from
**Southern
Water**

Our ref
PLAN-031769

Proposal: Refurbishment of redundant garage & change of use to allow for sleeping & bathing.
Site: AL/1/20/HH: - St Helier Hook Lane, Aldingbourne, PO20 3TE.

Screen Print

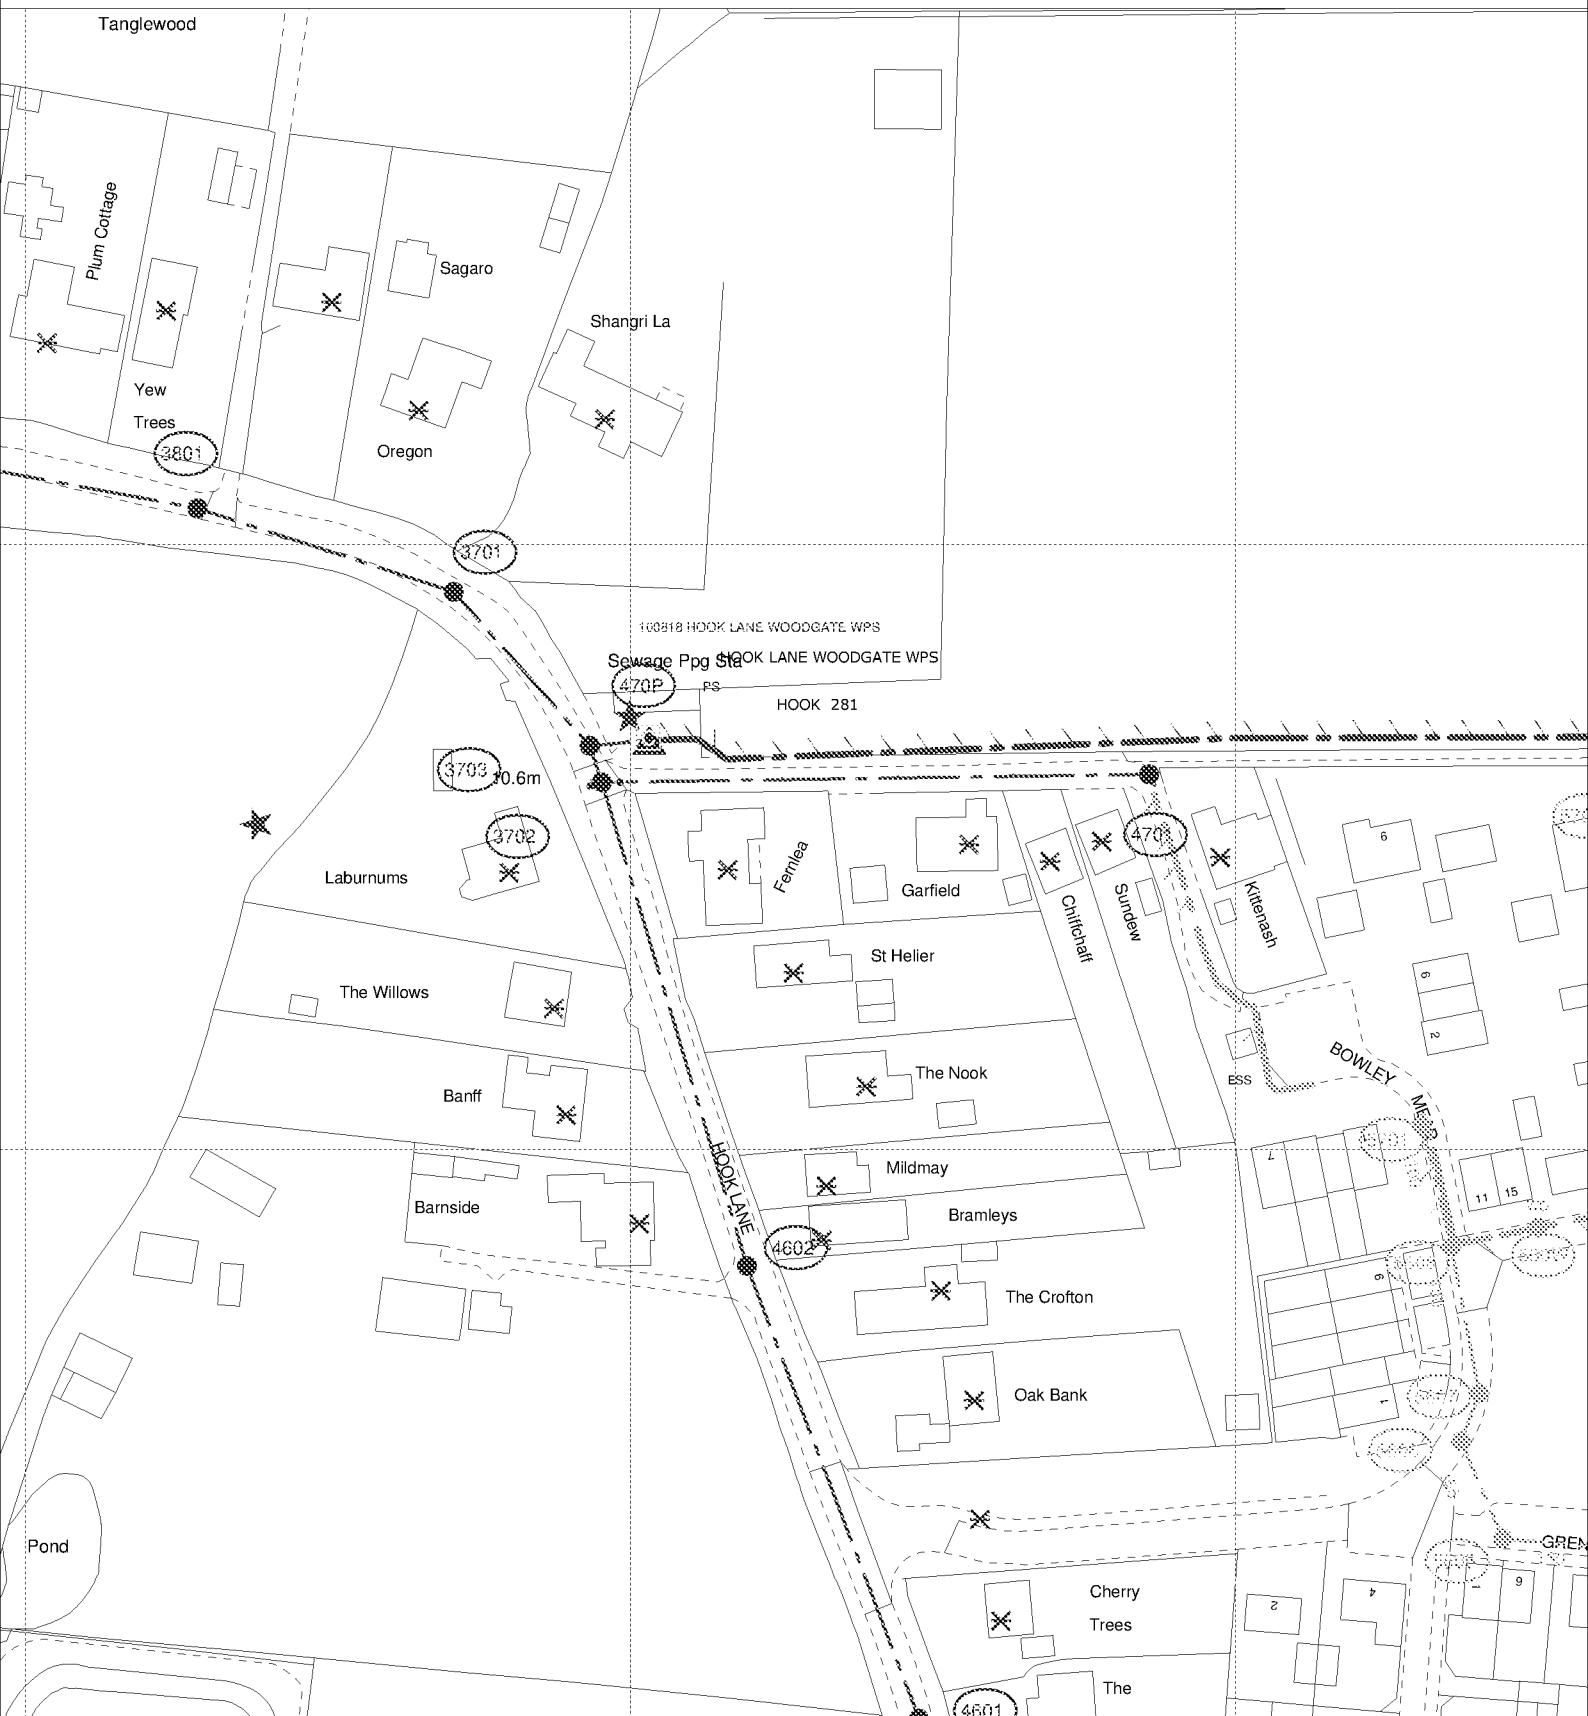
It is possible that a sewer now deemed to be public could be crossing the development site. Therefore, should any sewer be found during construction works, an investigation of the sewer will be required to ascertain its ownership before any further works commence on site.

The positions of pipes shown on this plan are believed to be correct, but Southern Water Services Ltd accept no responsibility in the event of inaccuracy. The actual positions should be determined on site.
